LR-N04-0040

**RESPONSE TO REQUEST FOR ADDITIONAL INFORMATION  
REGARDING RELIEF REQUEST S1-RR-I3-B21,  
NRC ORDER EA-03-009 ON REACTOR PRESSURE VESSEL HEAD INSPECTIONS  
SALEM GENERATING STATION UNIT NO. 1  
FACILITY OPERATING LICENSE NO. DPR-70  
DOCKET NO. 50-272**

**SALEM GENERATING STATION  
UNIT NO. 1  
FACILITY OPERATING LICENSE NO. DPR-70  
DOCKET NO. 50-272  
REQUEST FOR ADDITIONAL INFORMATION  
RELIEF REQUEST S1-RR-I3-B21  
NRC ORDER EA-03-009**

Figure 3-1  
Trinity Probe – Lower TOFD Transducer at Top of Chamfer

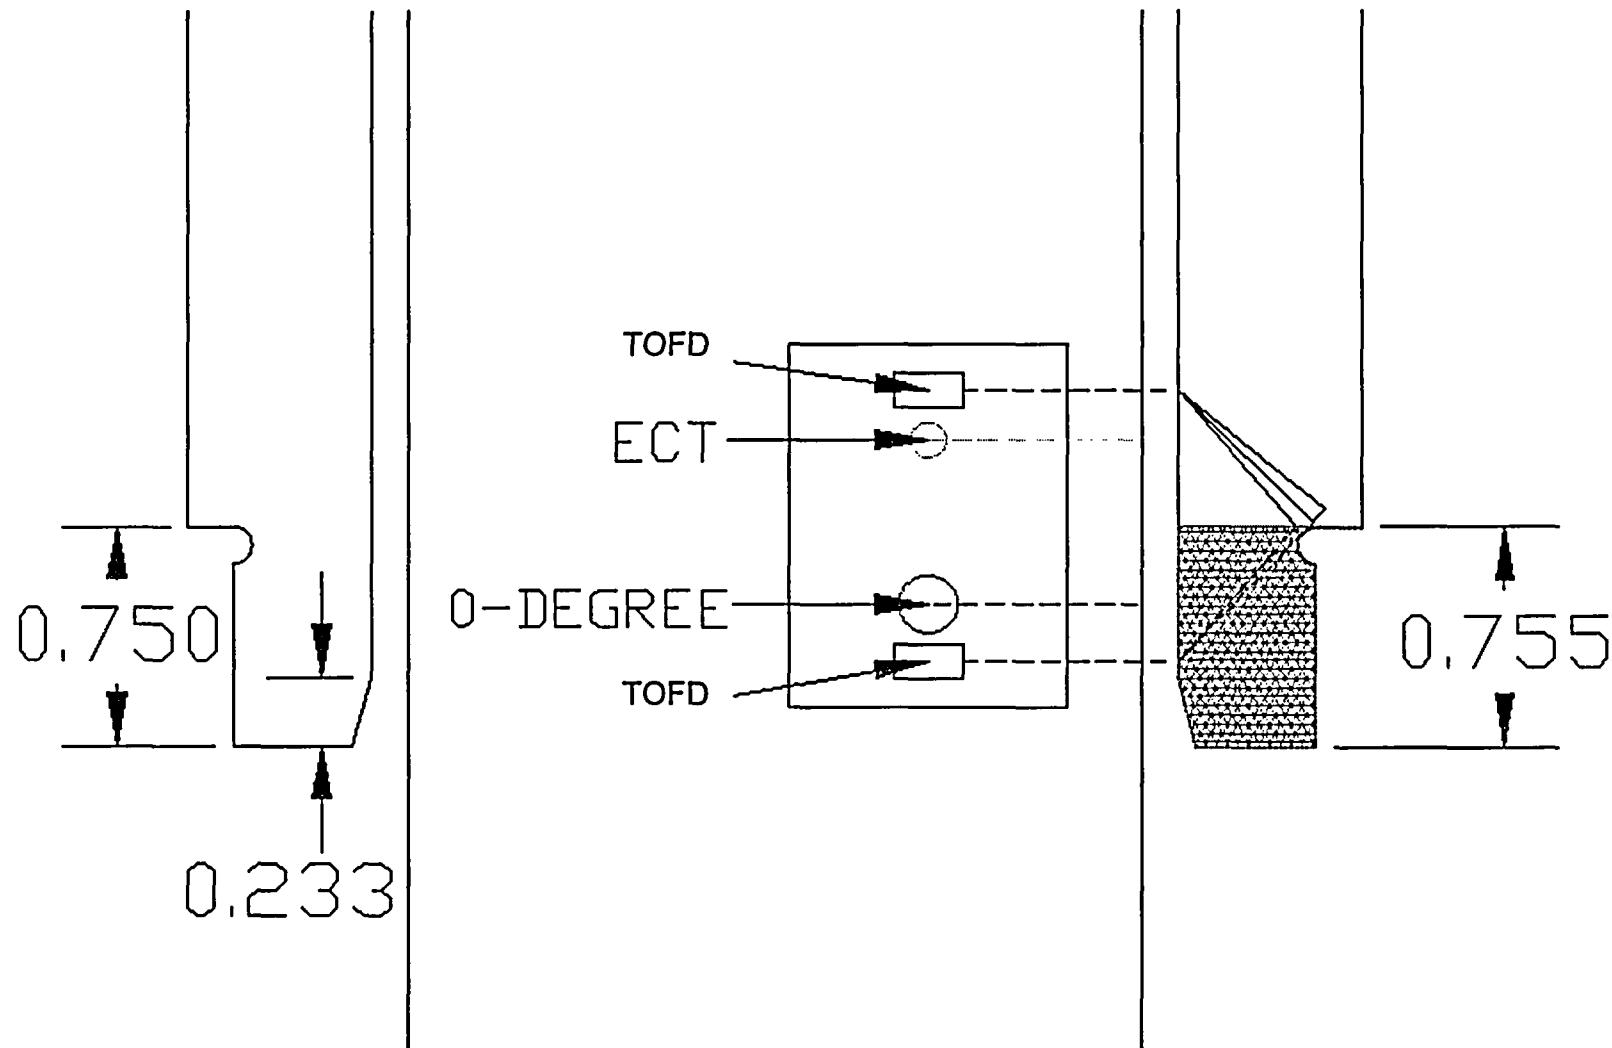
Provide cross section drawings showing limitations of the UT examinations (nozzle design and test equipment). What is the expected examination volume for the different nozzle angles and designs?

The penetration nozzles installed in the Salem Unit 1 Reactor Vessel head have a 15 degree chamfer that is 0.233 inches deep on the inside diameter (ID) of the tube. There is also a threaded area with a thread relief on the outer diameter of the tube that extends up 0.75 inches from the bottom. These geometries limit the coverage for both of the UT inspection tools that will be used at Salem. When the lower transducer on the probes goes below the top of the ID chamfer, the probes lose contact with the ID surface and it is not possible to obtain data.

Westinghouse will use two probes to perform UT inspection of the penetration nozzles at Salem. The trinity probe will be used to inspect nozzles that contain thermal sleeves (53) and part-length CRDM drive shafts (7 total). The open housing probe will be used to inspect nozzles without thermal sleeves (19 total). Both probes use circumferential time of flight tip diffraction (TOFD) as the primary crack detection method. The TOFD technique uses two transducers (one a transmitter, and one a receiver). For detection of circumferential cracks, the transducers are oriented along the vertical axis of the probe. The focus point of the TOFD beam is at the midpoint between the upper and lower transducers. Credit is only taken for inspecting areas that are covered by the focus point. The open housing probe has a PCS-24 transducer with a 55 degree angle of refraction. The Trinity Probe has a PCS-23.4 transducer with a 44 degree angle of refraction. The transducer spacing for the Trinity Probe is less than that of the open housing probe and the transducers are also a smaller size. This causes the focus point of the Trinity Probe transducers to be at a lower elevation than the open housing probe focus point when the probes reach the top of the ID chamfer. Therefore, the Trinity Probe would cover more area at the bottom of the tube. However, due to the difference in the refracted angles, the thread relief on the outside diameter (OD) of the tube interferes with the TOFD beam for the Trinity Probe. So there is an additional area above the thread relief where the Trinity Probe cannot inspect. Figure 3-1 shows the lower transducer at the top of the ID chamfer and the TOFD beam interference with the OD thread relief. Figure 3-2 shows the probe at the minimum elevation where the TOFD beam is not interrupted by the thread relief. The hashed areas from both figures make up the total portion of the tube that cannot be inspected. The dimensions listed in the Table 3-1 are based on the maximum coverage limitation of 0.851 inches shown in the Figure 3-2. With the PCS-24 transducer, the open housing probe circumferential TOFD beam is not interrupted by the OD thread relief. In addition to the circumferential TOFD transducer, the open housing probe has an axial TOFD transducer that the Trinity Probe does not have. The axial TOFD signal allows the open housing probe to inspect the tube down to the top of the ID chamfer. The dimensions listed in the Table 3-1 reflect the axial TOFD transducer coverage limitation of 0.233 inches. This is why the open housing probe coverage is consistently greater than the Trinity Probe coverage. Figure 3-3 shows both the axial and circumferential open housing probe TOFD coverage.

**Hoop Stress Distribution Downhill and Uphill Side  
(0° CRDM Penetration Nozzle)**

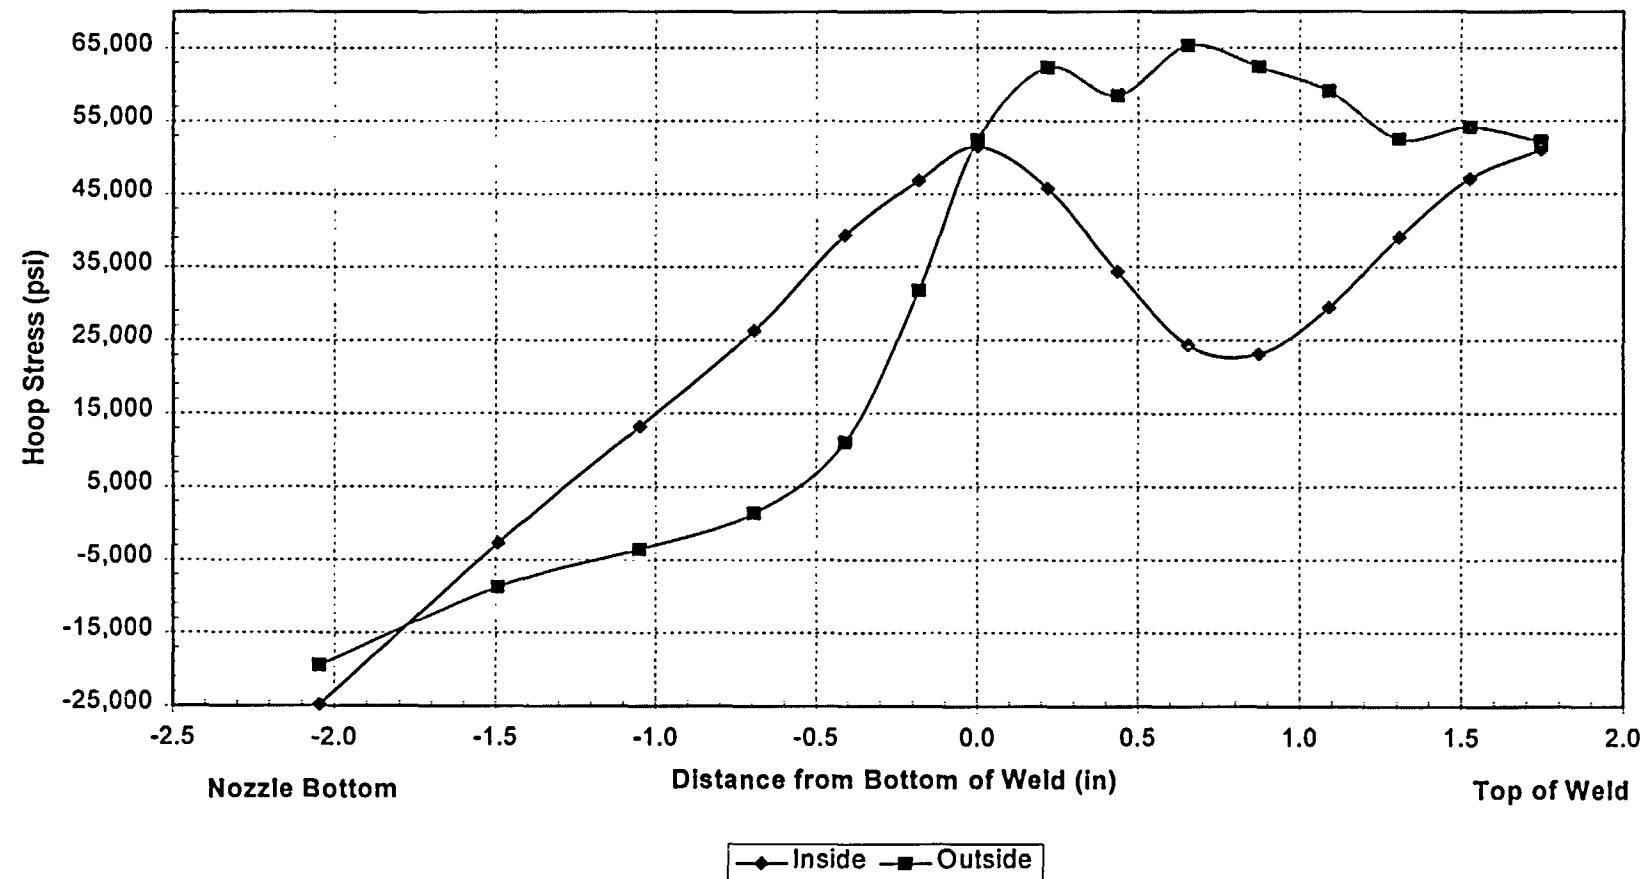
The request states that "UT of the most highly stressed portion of the nozzle (the weld heat affected zone) is unaffected by this limitation." Provide tabular listings or graphs of the maximum stresses in the cross-section from the top of the J-groove weld region to the nozzle end for a range of nozzle angles.

Figures 8-1 through 8-7 are graphs of the inside and outside surface hoop stress distribution from the top of the J-weld to the bottom of the head penetration nozzles. Graphs are provided for the uphill side and the downhill side of the head penetrations for four nozzle angles. There are a total of 15 nozzle angles for the head penetrations at Salem Unit 1. Selected rows of penetrations and the center penetration were analyzed to provide additional results so that a trend can be established as a function of radial location. The penetration nozzle angles selected for this analysis consist of the center penetration (0-degrees), the outermost penetration ( $48.7^\circ$ ) and two angles in between the center and the outermost penetrations ( $26.2^\circ$  and  $44.3^\circ$ ).

**Figure 9-1**  
**Through-Wall Axial Crack Growth with Initial Upper Crack Tip located at 0.5 inch Below the Weld (Center CRDM Penetration)**

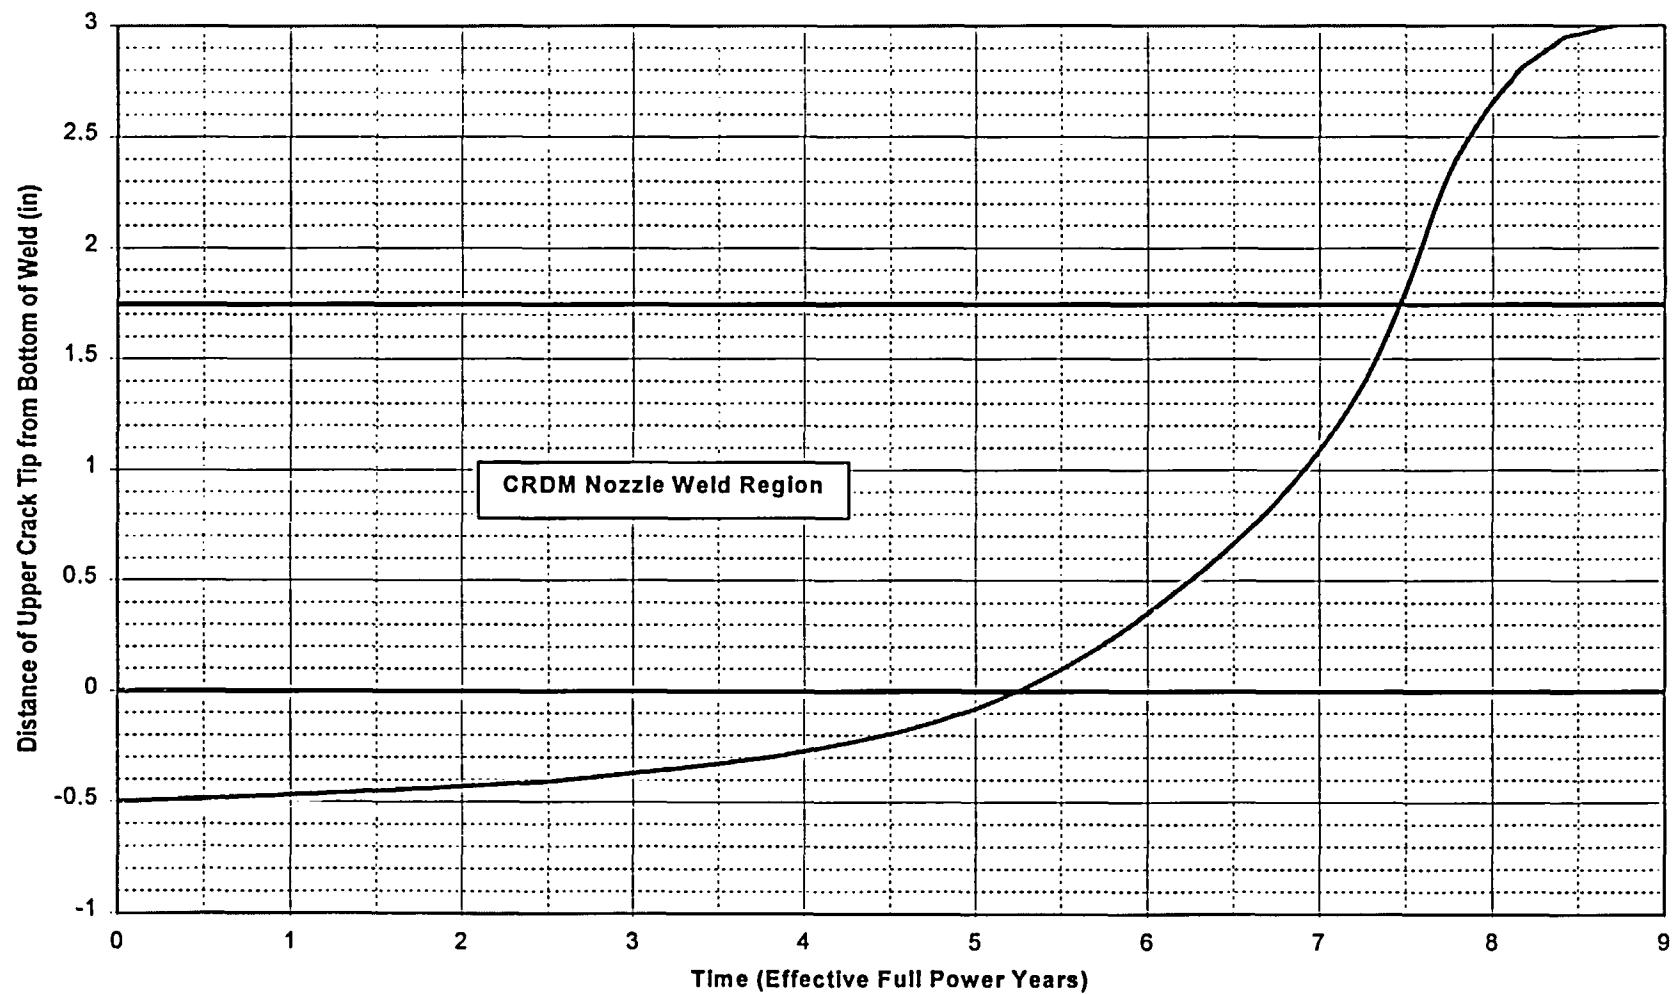
Provide a technical justification, such as an analysis or an evaluation, to show that cracks initiated from the unexamined area will not propagate into the pressure boundary and exceed the ASME Code allowable crack sizes within a minimum of one operating cycle using a conservative crack-growth rate from industry experience. Describe uncertainties in this calculation (e.g., stress levels, crack-growth rate, etc.) and the uncertainty in the results.

A crack growth calculation below the calculated distance below the tip of the weld was performed demonstrating that more than one operating cycle would elapse before a postulated flaw in the unexamined area of the penetration nozzle would propagate into the pressure boundary formed by the J-groove weld. An operating cycle for Salem Unit 1 is 1.5 calendar years, and is typically less than 1.5 Effective Full Power Year (EFPY). The methodology and the technical basis of the crack growth calculation, which was based on the hoop stress distribution provided in the response to Question 8 and the Primary Water Stress Corrosion Cracking (PWSCC) crack growth rate recommended in MRP-55 Rev.1, are provided in WCAP-16214-P, Structural Integrity Evaluation of Reactor Vessel Upper Head Penetrations to Support Continued Operation: Salem Units 1 and 2.

The distance below the J-groove weld to the top of the zone that cannot be inspected has been calculated to be more than 1 inch based on design dimensions (see Table 3-1) with the downhill side of the penetration nozzle being more limiting. However, the upper extremity of an axial through-wall flaw was conservatively postulated to be located at 0.5 inches or less below the J-groove weld in the crack propagation calculation for the downhill side of the penetration nozzle. Figures 9-1 through 9-4 provide results of the calculation. The calculation demonstrates that the minimum time for a flaw to propagate from that location to the bottom of the J-groove weld would be at least 3 EFPY, which is more than 2 operating cycles.

The results of the flaw propagation calculation indicate that, even if a flaw were to occur in the region of the penetration nozzle not being inspected, there would be adequate opportunity for detection prior to the crack reaching the reactor coolant system pressure boundary. The result demonstrates that the extent of the proposed inspection coverage would provide reasonable assurance for the structural integrity of the Unit 1 RPV head penetration nozzles and the J-groove welds.
